UPDATE NOTE: STELLANTIS ENGINE 1.5L BLUEHDI DV5 YH

FRECCIA SOLUTION

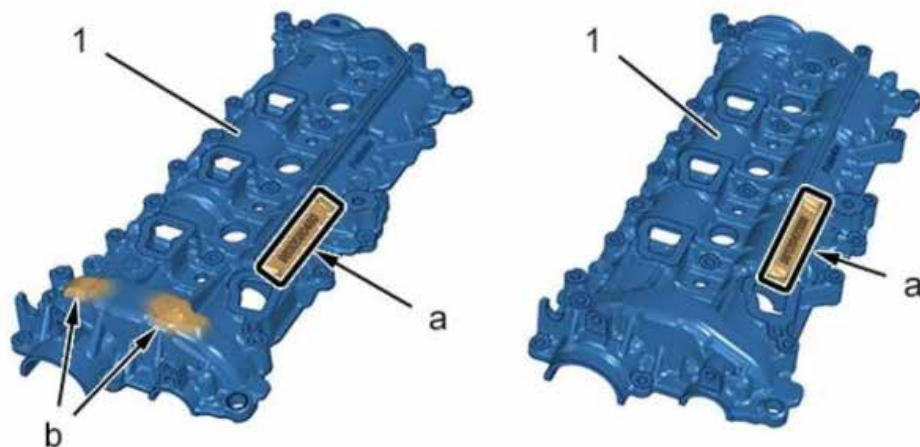
In the 1.5 BlueHDi engine developed by Stellantis in 2019, critical issues may be encountered due to premature wear of the timing chain, a chain which, if not replaced when excessive noise occurs can break, causing extensive damage to the engine. Aware of the problem, Stellantis technicians have made significant changes to the engine since January 2023, with the adoption of an 8 mm timing chain instead of 7 mm, new camshafts and a new valve cover. To recognize the pre-modified version, it is necessary to analyze the valve cover: the updated version **has two small protuberances (b)** and a **rounded design around the shafts (1)** as highlighted in the drawing below. The original reference number has also changed: **98 305 804 80 (a)**.
